**TO:** Planning Commission  
**FROM:** Andrea Landers, Zoning Official  
**DATE:** May 28, 2025  
**SUBJECT:** 01-PUD-03-25 (05-SPR-06-25) – Preliminary PUD plan review for W. Magnetic St (Portion of PIN: 0410681))

**File Number:** 01-PUD-03-25 (05-SPR-06-25)

**Project/Application:** Preliminary PUD Approval and Site Plan Review for a proposed Planned Unit Development (PUD) for a mixture of Townhome types (one-unit, duplex, triplex, and six-unit) for a total of 36 units to be located at the three existing parking lots on the south side of W. Magnetic Street between Lee Street and Fourth Street.

ISSUE DATE	FOR	Designed By:
4/22/25	REVIEW	LBS
5/5/25	REVIEW	Checked By: BMS
		Drawn By: LBS
		Approved By: BMS
		PROJECT # 24042
		SHEET NO. 13
		DWG. NO. C-04.2

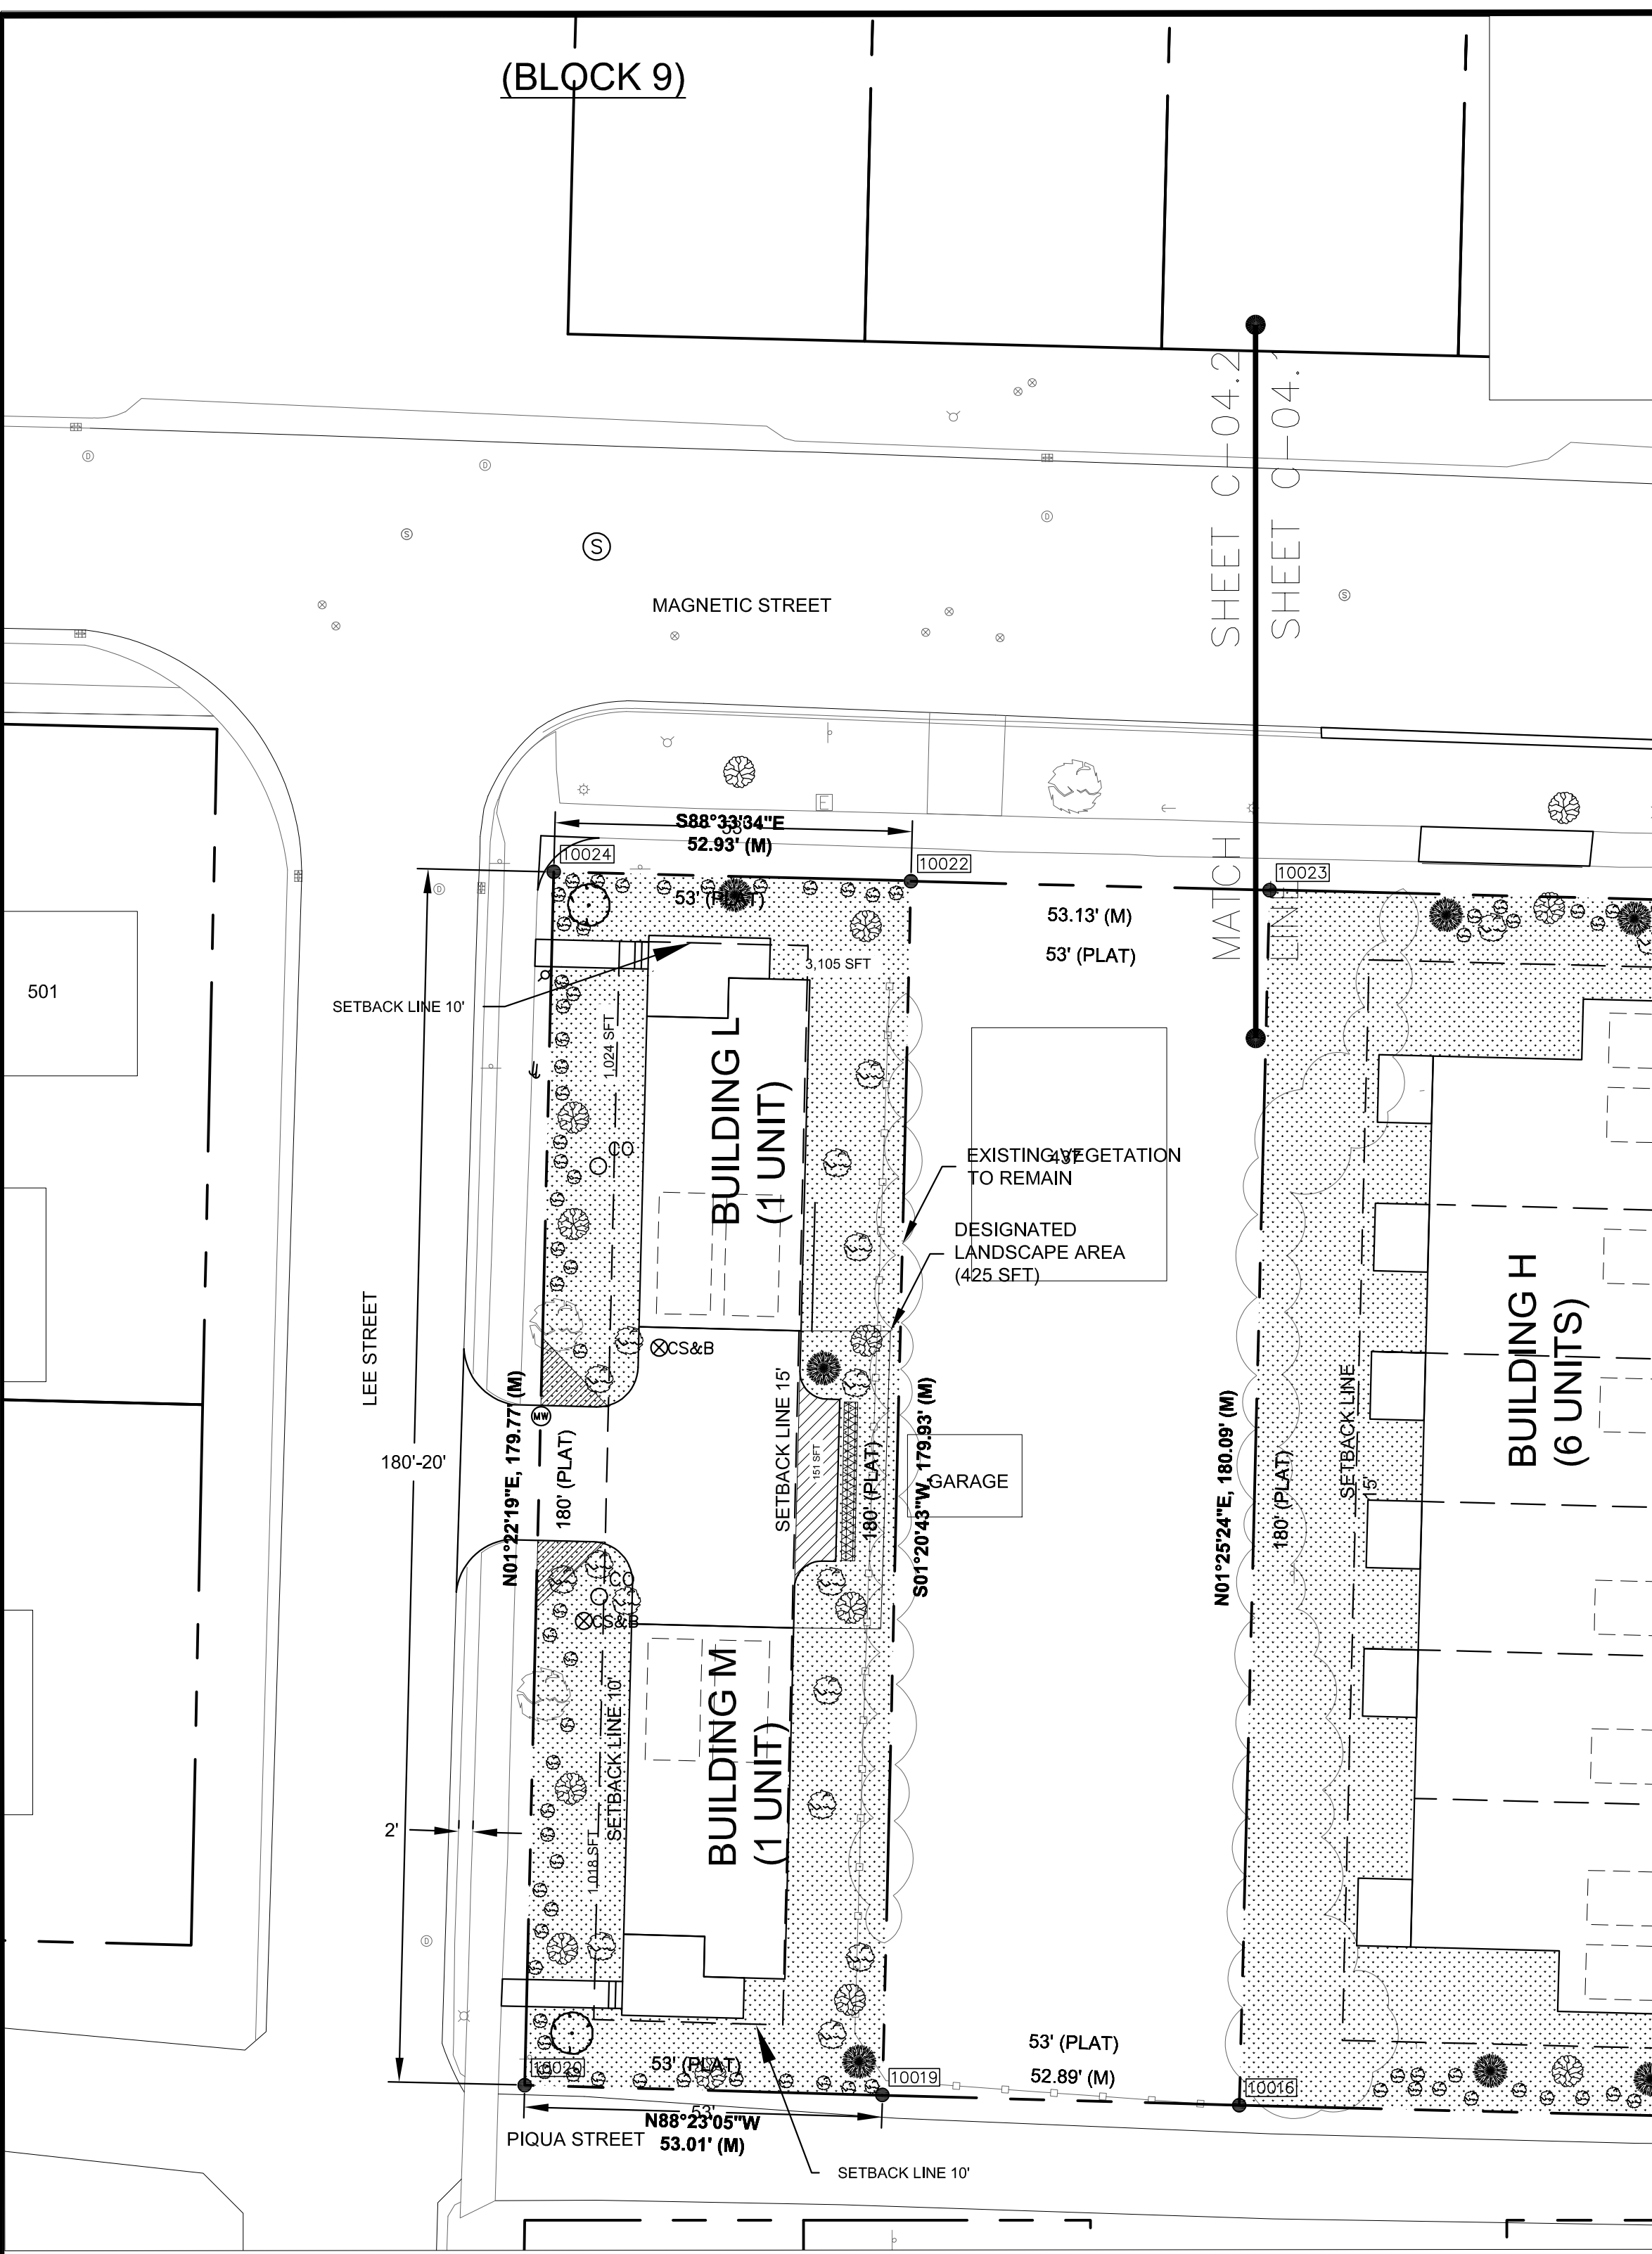
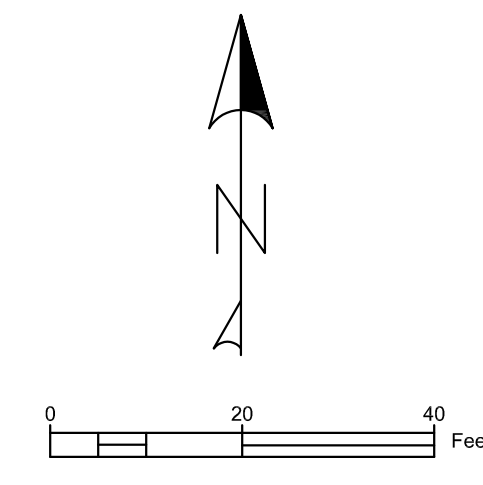
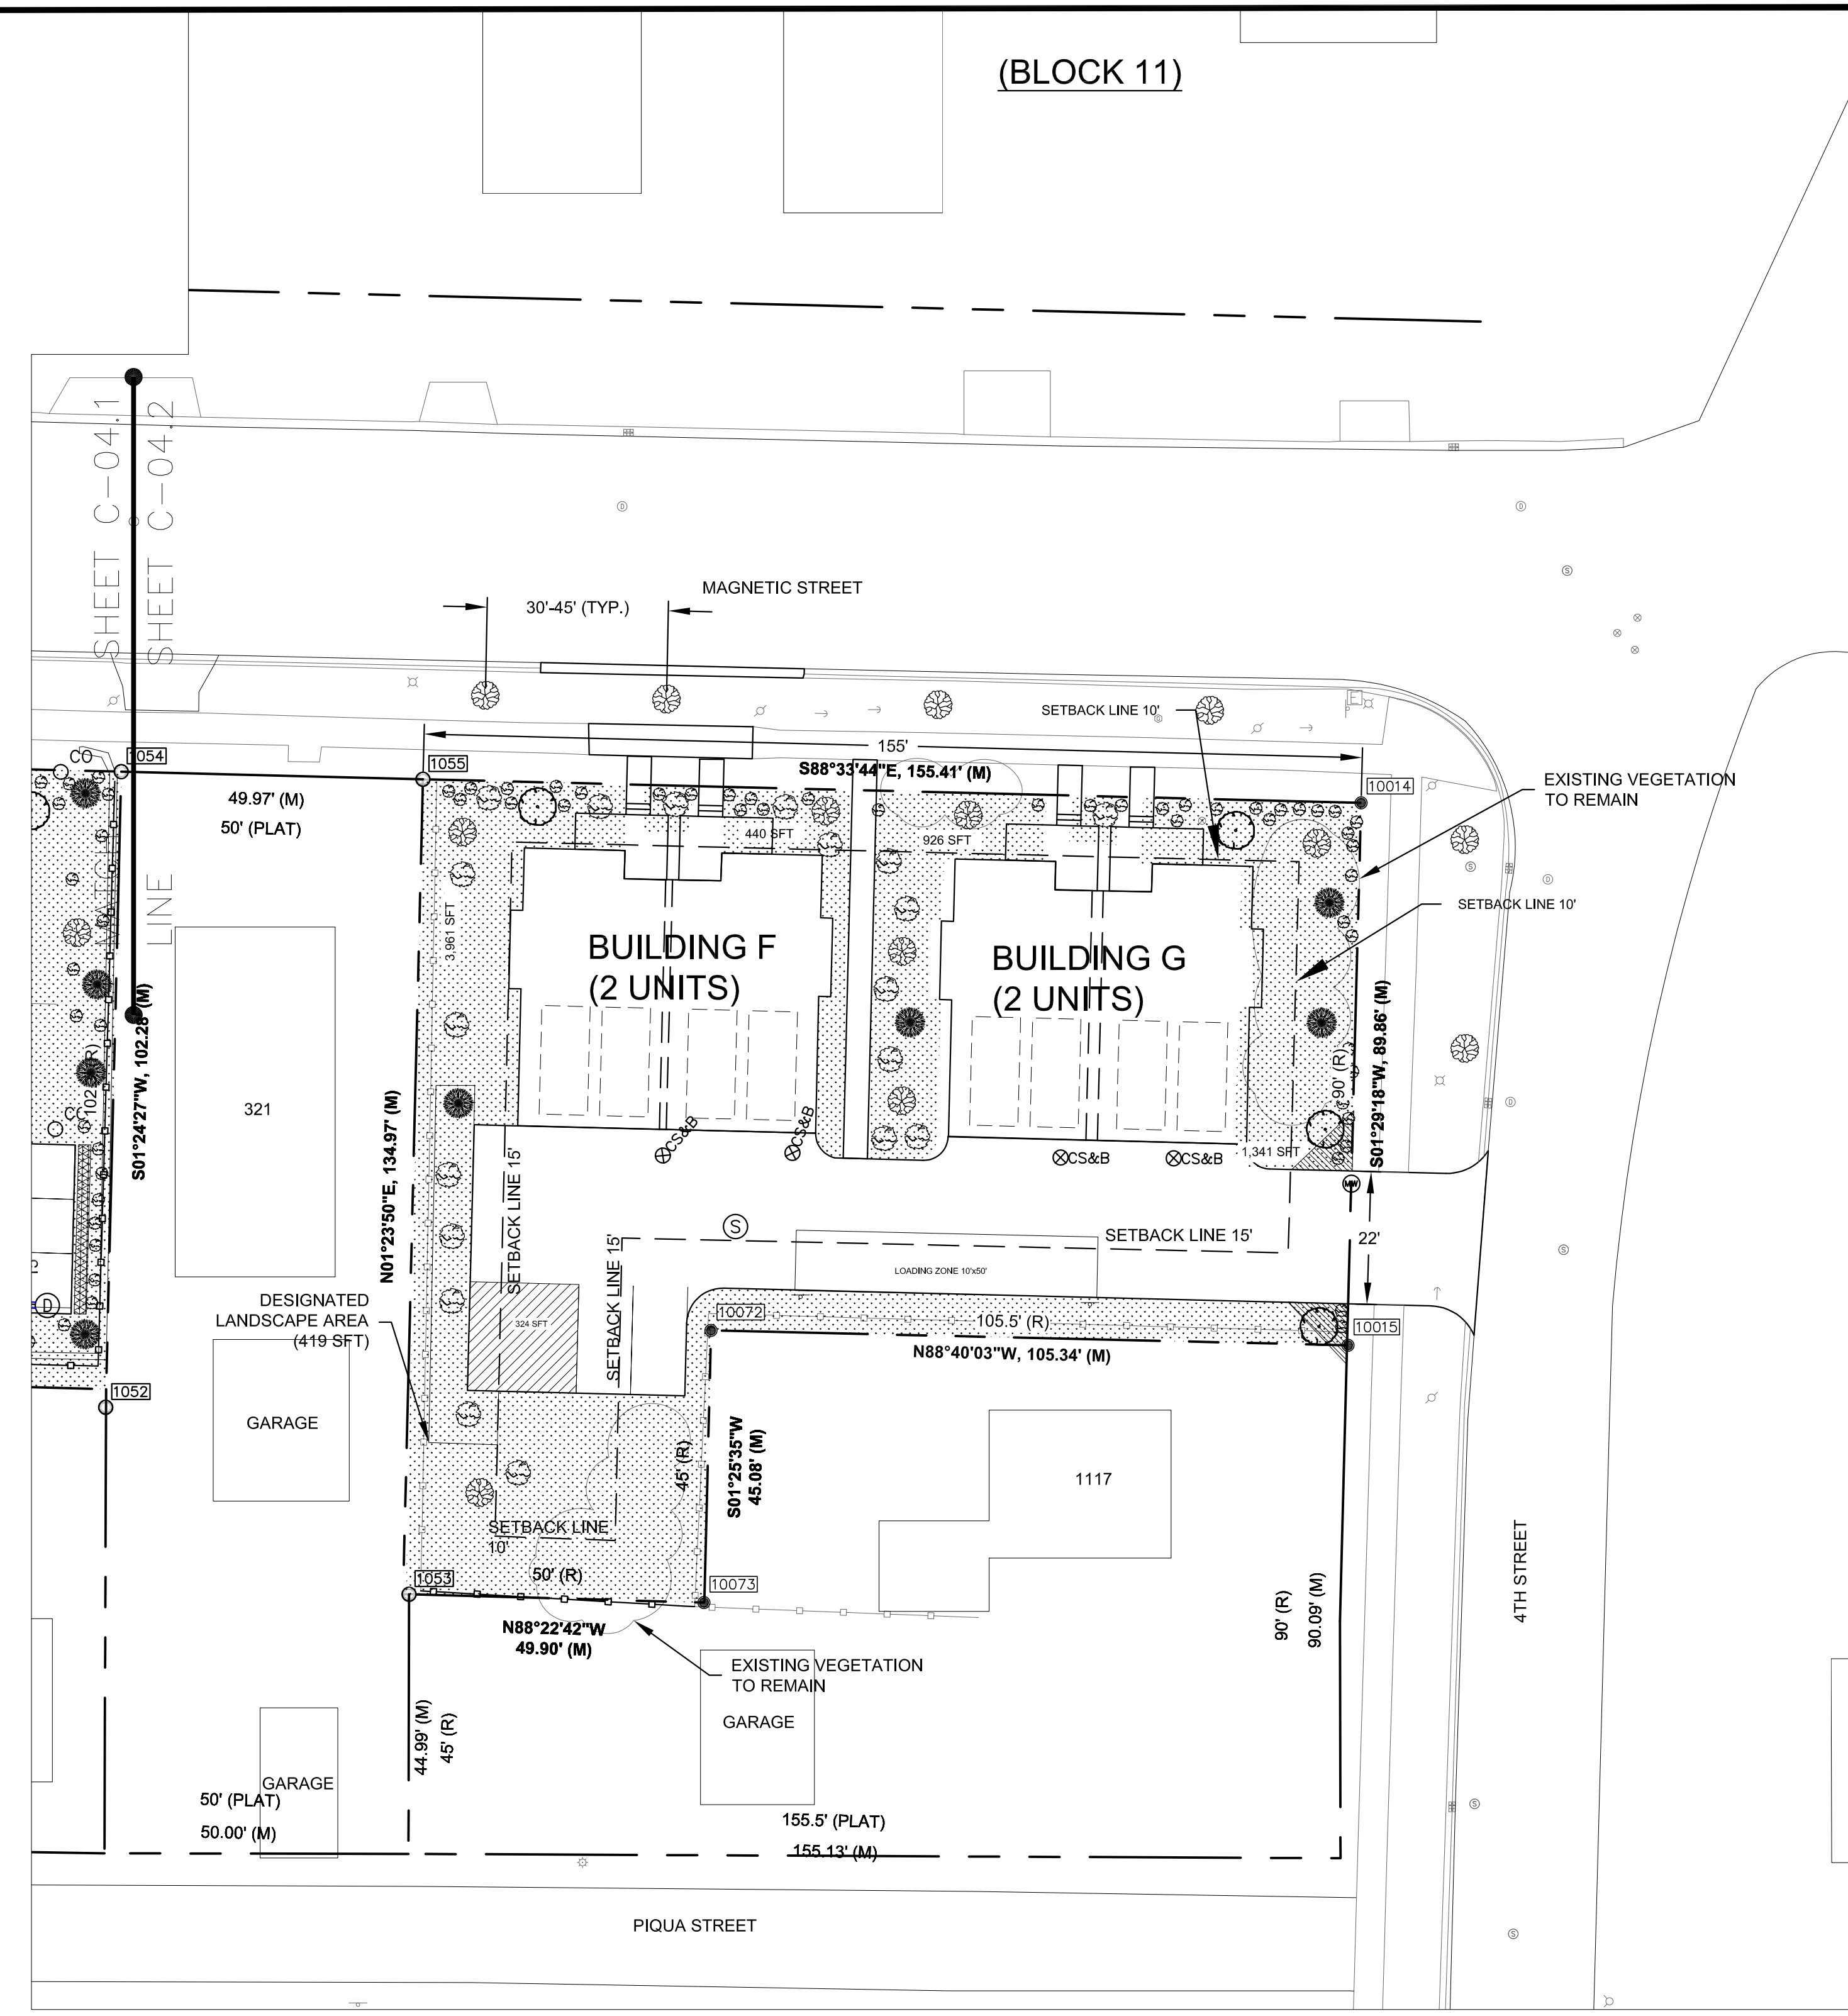
**See Sheets C-04.1 and C-04.2 for the landscaping plan. Please see Zoning comments and applicant's responses regarding the proposed landscaping for the site.**

- **Section PUD (H)(1)(K) – We have Added Notation to the Landscape Plan sheets C-04.1 and C-04.2 indicating that all of the Green Area and Buffer Yard Landscape areas will be permanently preserved, and the Condominium Association will be responsible to provide annual maintenance of these areas and provide re-planting as necessary.**

- **On Sheet C-04.1 we have also added notation that the large green space including the proposed Pavilion will be permanently preserved area for the entire Condominium Association.**
